# CITY OF ALBUQUERQUE

**RE: Lot 5 Block 5 Unit 5 SAD 227  
6508 Onyx Ct. NW  
Grading and Drainage Plan  
Engineers Stamp Date 5/4/2020 (E10D069)  
Pad Certification Date 10/23/2020**

## DRAINAGE AND TRANSPORTATION INFORMATION SHEET (REV 6/2018)

ENGINEER'S SEAL 	LOT 5 BLOCK 5 UNSER CLIFFS SUB 6508 ONYX COURT N.W.  GRADING AND DRAINAGE PLAN  	DRAWN BY DEM
		DATE 5-4-20
DAVID SOULE P.E. #14522	1608 CENTRAL AVENUE SE SUITE 201 ALBUQUERQUE, NM 87106 (505) 972-0899	SHEET #  C1
		JOB #

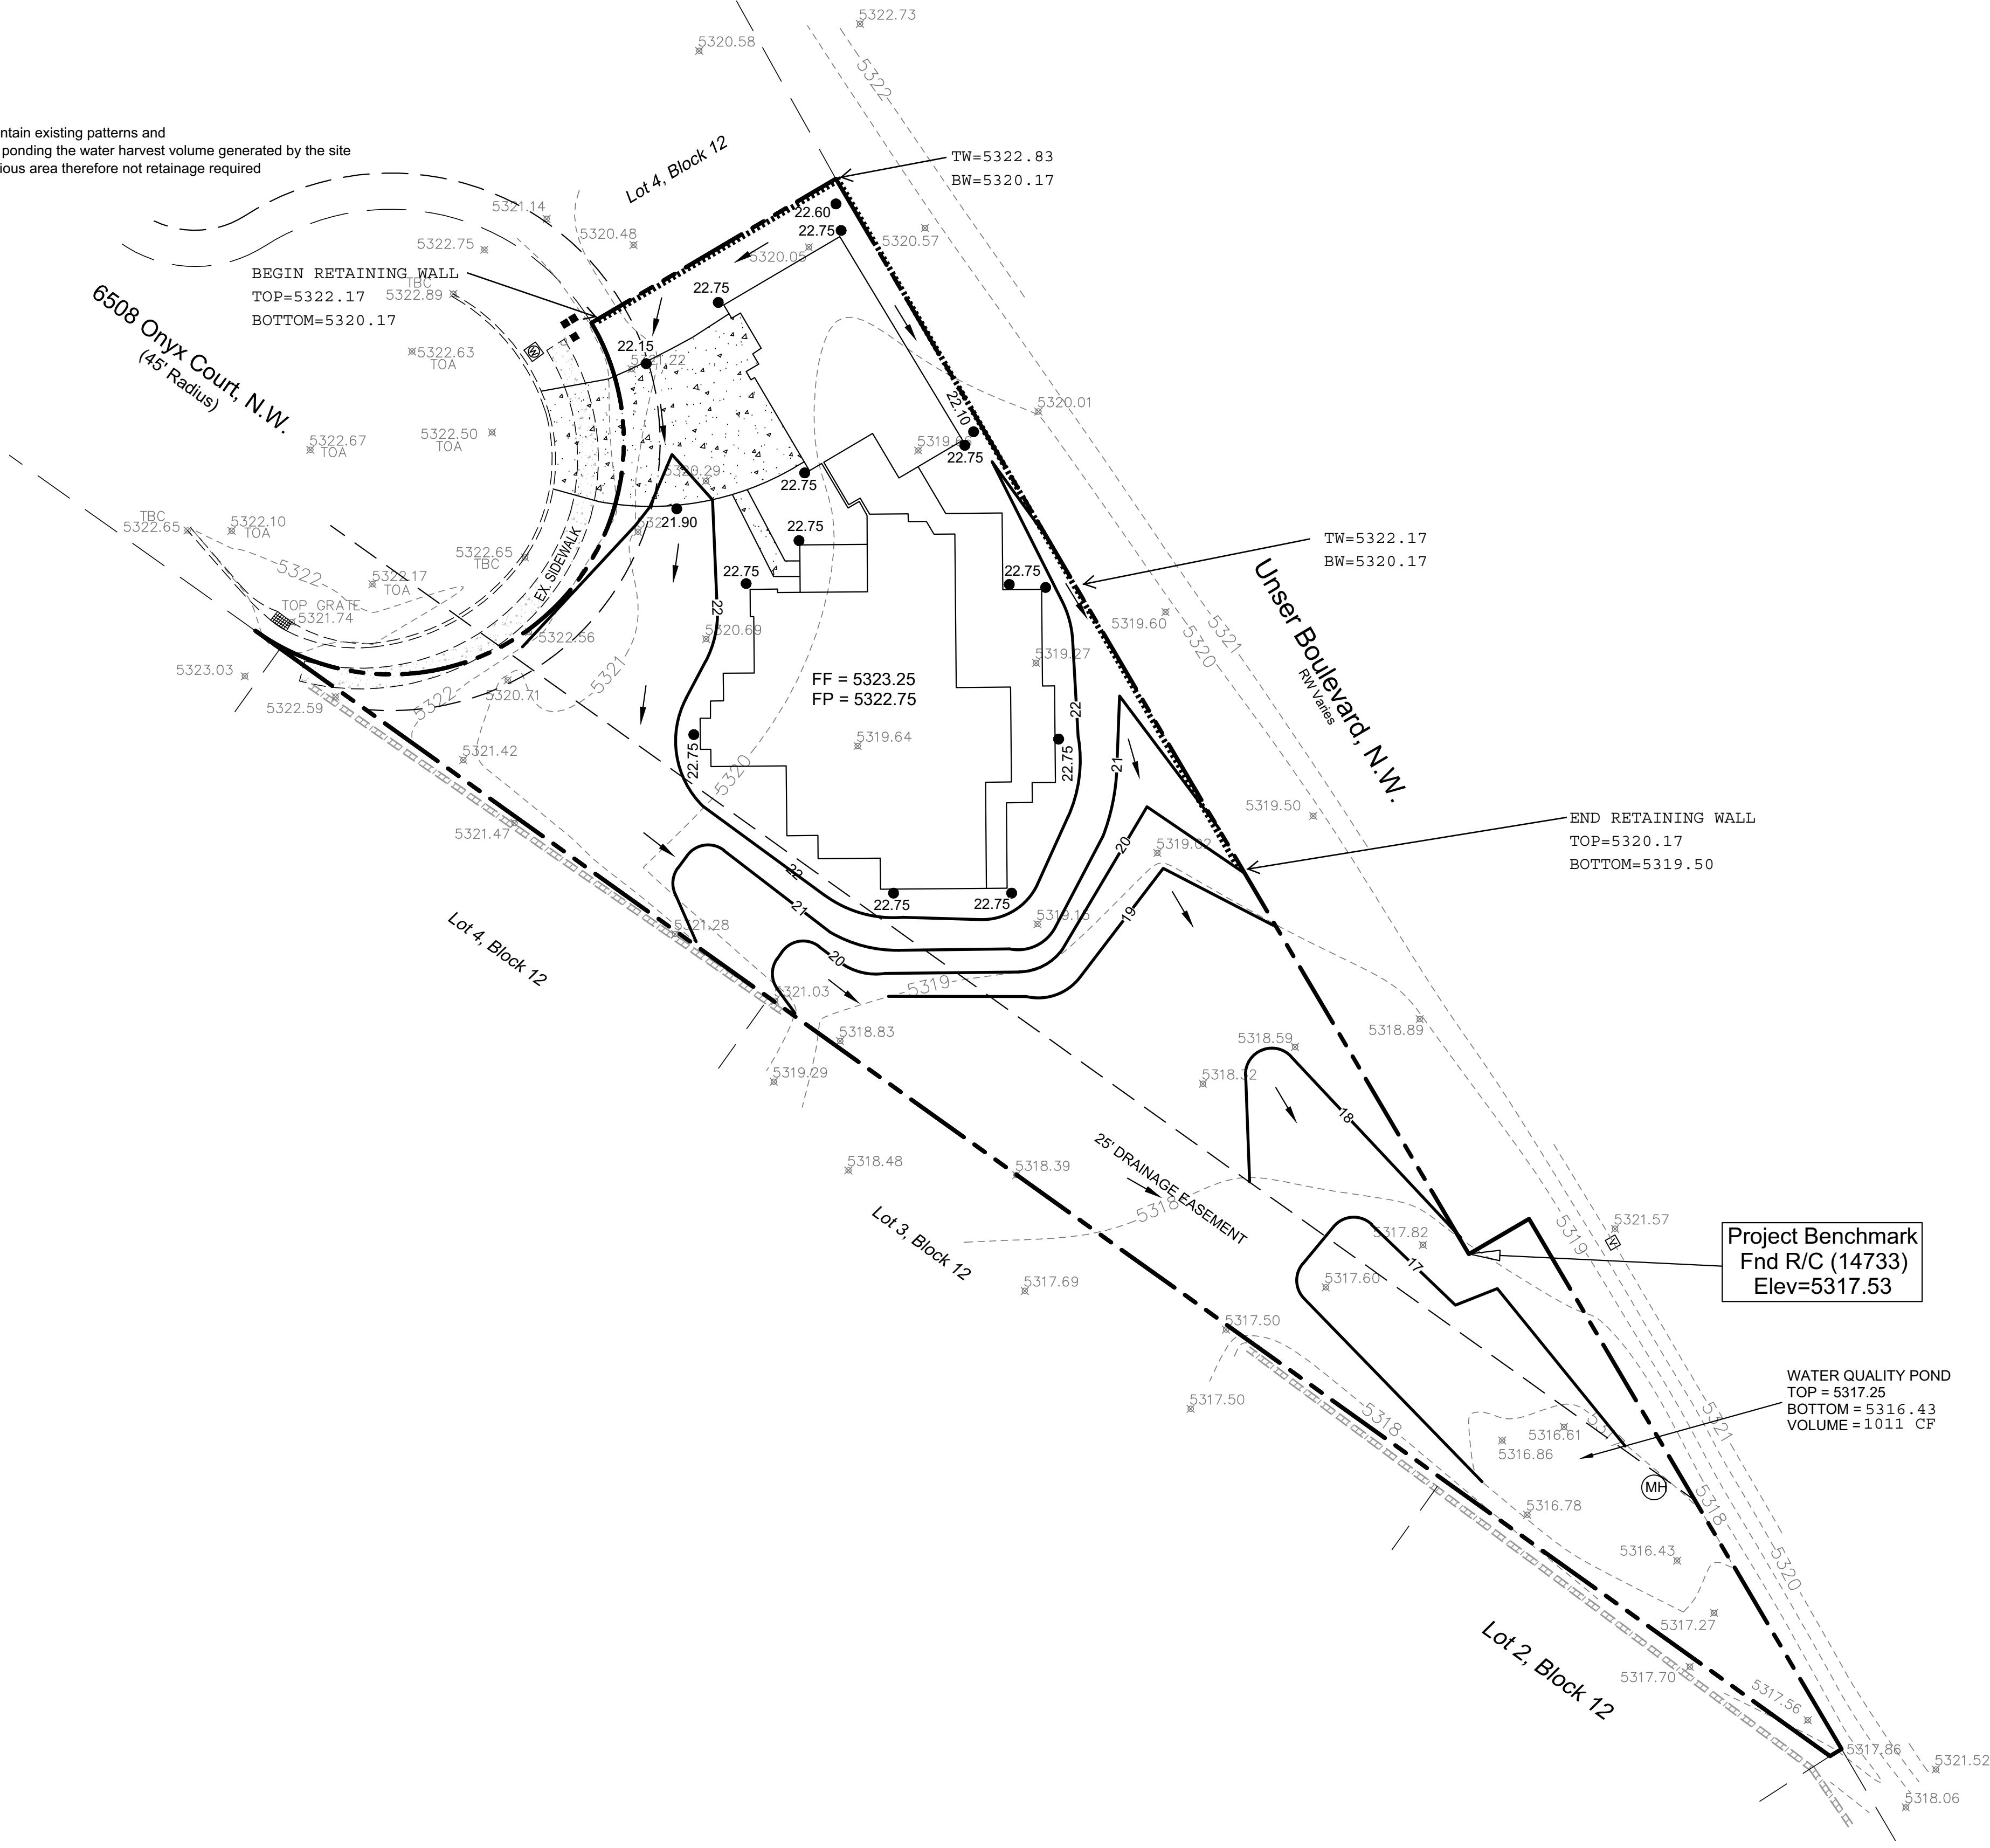
Based upon the information provided in your submittal received 11/5/2020, this plan is approved for Building Permit.

Reiterate to the Owner/Contractor that a separate permit for a garden/retaining wall must be obtained, with the approved G&D plan.

Prior to Certificate of Occupancy release, Engineer Certification per the DPM checklist of this plan will be required.
